WC36 - Replacing Retaining Clip for Temperature Sensor (Workshop Campaign)

Vehicle Type: **Cayenne Diesel (92A)**

Model Year: **2012**

Concerns: **Retaining clip for coolant temperature sensor in the coolant hose**

Figure 1

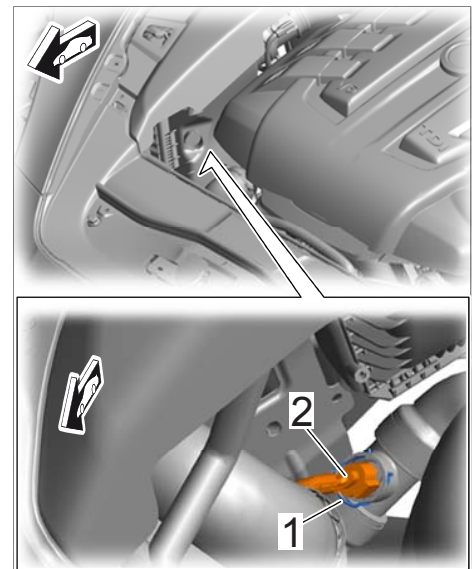
Information: This is to inform you of a voluntary Workshop Campaign on the above-mentioned vehicles.
There is a possibility that retaining clips of the wrong size were used to secure the coolant temperature sensor on the affected vehicles due to a supplier error.

As a result, the retaining clip can become detached from the temperature sensor.

Action Required: Replace the retaining clip for the coolant temperature sensor prior to vehicle delivery to customers.

- 3 Replace retaining clip for coolant temperature sensor.
- 3.1 Pull off retaining clip ⇒ *Figure 1 -1-* for the temperature sensor ⇒ *Figure 1 -2-* using a pliers. Hold the temperature sensor firmly while doing this to prevent it from slipping out of the coolant hose connecting piece.
- 3.2 **Fit new** retaining clip ⇒ *Figure 1 -1-*, Part No. **000.043.207.93**, on the temperature sensor ⇒ *Figure 1 -2-*.
- 4 Close front lid.
- 5 Enter the workshop campaign in the Warranty and Maintenance booklet.
